Access Compliance Report Public Rights-of-Way (Curb Ramps)

Main Street: CECIL_PASTURE_RD Cross Street: O_NEILL_DR Location: NW

ADA ID: RPRK211025142458 Ramp Type: Type 4 - Parallel Initial Pass/Fail: Fail Overall Compliance: No Severity Score: 45

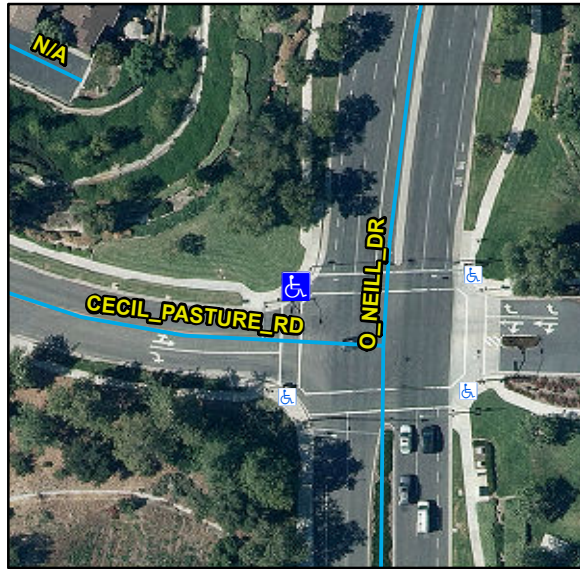
R204.3, R304.3.2, R304.5.3, STD 1115

Compliance	Description	Data	Compliance	Description	Data
N/A	Ramp Length LT (in)	120	N/A	Ramp Length RT (in)	119
Yes	Ramp Width LT (in)	82	Yes	Ramp Width RT (in)	89
No	Ramp Run Slope LT (%)	8.7	Yes	Ramp Run Slope RT (%)	4.4
Yes	Ramp Cross Slope LT (%)	0.5	No	Ramp Cross Slope RT (%)	7.4
N/A	Landing Present	N/A	N/A	DWS Provided	N/A
N/A	Landing Length (in)	N/A	N/A	DWS Contrast	N/A
N/A	Landing Width (in)	N/A	N/A	DWS Length (in)	N/A
N/A	Landing Run Slope (%)	N/A	N/A	DWS Full Width	N/A
N/A	Landing Cross Slope (%)	N/A		DWS Offset Type	N/A
N/A	Landing Movement Obstructed?	N/A	N/A	DWS Offset Left (in)	N/A
	Landing Movement Type	N/A	N/A	DWS Offset Right (in)	N/A
N/A	Landing Shared	N/A			
N/A	Clear Space	Yes			
N/A	Clear Space To Crosswalk (in)	48			
N/A	Marked Crosswalk 1	Yes	N/A	Marked Crosswalk 2	Yes
	Crossing 1 Direction	S		Crossing 2 Direction	E
	Marked Crosswalk 1 Width (in)	144		Marked Crosswalk 2 Width (in)	144

Remove & Replace Curb Ramp With Two New Directional Ramps or Equivalent.
